Access Compliance Report

Public Rights-of-Way

(Curb Ramps)

Intersection ID: 27355	Main Street: JOHNSTON_RD	Cross Street: BRIXHAM_AV	Location: NE
ADA ID: 8E9ADD38D0DE	Ramp Type: Perpendicular Diagonal	Initial Pass/Fail: Fail	Overall Compliance: No
Severity Score: 22.5			
Codes/Mitigation Info/Possible Solution		Field Measurements/Component Compliance

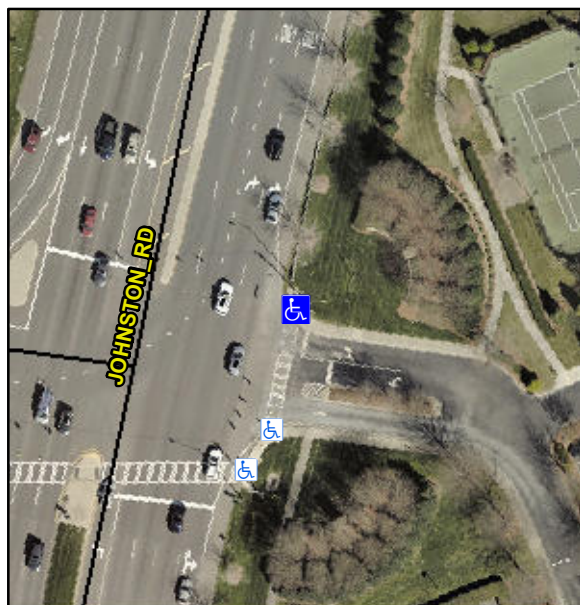
R304.5.1, R304.2.2, R304.5.3

Compliance	Description	Data	Compliance	Description	Data
N/A	Ramp Length (in)	61.0	No	Ramp Slope (%)	9.2
No	Ramp Width (in)	41.0	No	Ramp XSlope (%)	4.0
N/A	Flare Type LT	N/A	N/A	Flare Type RT	N/A
N/A	Flare Slope LT (%)	N/A	N/A	Flare Slope RT (%)	N/A
N/A	Flare Traversable LT?	N/A	N/A	Flare Traversable RT?	N/A
N/A	Landing Length (in)	N/A	N/A	DWS Provided?	N/A
N/A	Landing Width (in)	N/A	N/A	DWS Contrast?	N/A
N/A	Landing Slope (%)	N/A	N/A	DWS Length (in)	N/A
N/A	Landing X Slope (%)	N/A	N/A	DWS Full Width?	N/A
N/A	Landing Curb? (Y/N)	N/A	N/A	DWS Offset (in)	N/A
N/A	Shared Landing?	N/A			
N/A	Gutter Ponding?	N/A	N/A	Gutter Slope (%)	N/A
N/A	Gutter Lip Ht (in)	N/A	N/A	Gutter X Slope (%)	N/A
N/A	Painted X Walk1?	No	N/A	Painted X Walk2?	Yes
	X Walk 1 Direction	To NW		X Walk 2 Direction	To SW
N/A	X Walk 1 Width (in)	N/A	N/A	X Walk 2 Width (in)	75.0
	X Walk 1 Slope (%)	0.3		X Walk 2 Slope (%)	2.3
	X Walk 1 X Slope (%)	2.8		X Walk 2 X Slope (%)	1.1

N/A	Ramp inside XWalk1?	N/A	N/A	Ramp inside XWalk2?	Yes
	Road Slope (%)	2.6	N/A	Clear Space?	N/A
	Road X Slope (%)	2.0	N/A	Clear Space to XWalk (in)	N/A
N/A	Any Obstructions?	N/A	N/A	Storm Grate/Utility Hazard?	N/A
	Obstruction Type			Storm Grate/Utility Type	
		N/A			N/A
		Yes		Surface Condition? (G/P)	Good

Remove & Replace Curb Ramp With Two New Directional Ramps or Equivalent.
